Access Compliance Report

Public Rights-of-Way

Intersection ID: 54114	Main Street: ENDAHVEN_VILLAGE_DR	Cross Street: ENDAHVEN_LN	Location: NE
ADA ID: 3FA5DD9A5D4E	Ramp Type: BlendTrans1	Initial Pass/Fail: Fail	Overall Compliance: No
Severity Score: 10			
Codes/Mitigation Info/Possible Solution		Field Measurements/Component Compliance

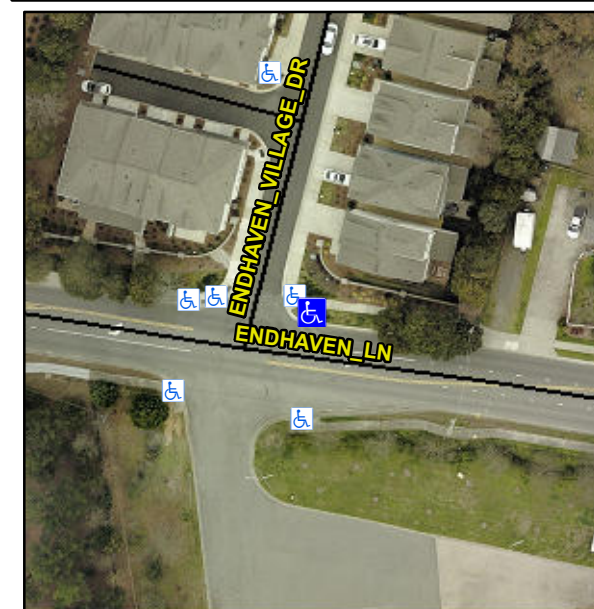
Compliance	Description	Data	Compliance	Description	Data
N/A	Ramp Length (in)	83.0	Yes	BlendTrans Slope (%)	3.8
No	Ramp Width (in)	46.0	No	BlendTrans XSlope (%)	3.4
N/A	Flare Type LT	N/A	N/A	Flare Type RT	N/A
N/A	Flare Slope LT (%)	N/A	N/A	Flare Slope RT (%)	N/A
N/A	Flare Traversable LT?	N/A	N/A	Flare Traversable RT?	N/A
N/A	Landing Length (in)	N/A	N/A	DWS Provided?	N/A
N/A	Landing Width (in)	N/A	N/A	DWS Contrast?	N/A
N/A	Landing Slope (%)	N/A	N/A	DWS Length (in)	N/A
N/A	Landing X Slope (%)	N/A	N/A	DWS Full Width?	N/A
N/A	Landing Curb? (Y/N)	N/A	N/A	DWS Offset (in)	N/A
N/A	Shared Landing?	N/A			
N/A	Gutter Ponding?	N/A	N/A	Gutter Slope (%)	N/A
N/A	Gutter Lip Ht (in)	N/A	N/A	Gutter X Slope (%)	N/A
N/A	Painted X Walk1?	No	N/A	Painted X Walk2?	N/A
	X Walk 1 Direction	To S		X Walk 2 Direction	N/A
	X Walk 1 Width (in)	N/A		X Walk 2 Width (in)	N/A
	X Walk 1 Slope (%)	3.2		X Walk 2 Slope (%)	N/A
	X Walk 1 X Slope (%)	2.7		X Walk 2 X Slope (%)	N/A

N/A	Ramp inside XWalk1?	N/A	N/A	Ramp inside XWalk2?	N/A
	Road Slope (%)	2.7		Clear Space?	N/A
	Road X Slope (%)	3.2	N/A	Clear Space to XWalk (in)	N/A
N/A	Any Obstructions?	N/A	N/A	Storm Grate/Utility Hazard?	N/A
	Obstruction Type			Storm Grate/Utility Type	
		N/A			N/A
			Yes	Surface Condition? (G/P)	Good
			N/A	Curb Slope (%)	0.8

Remove & Replace Curb Ramp With Two New Directional Ramps or Equivalent.
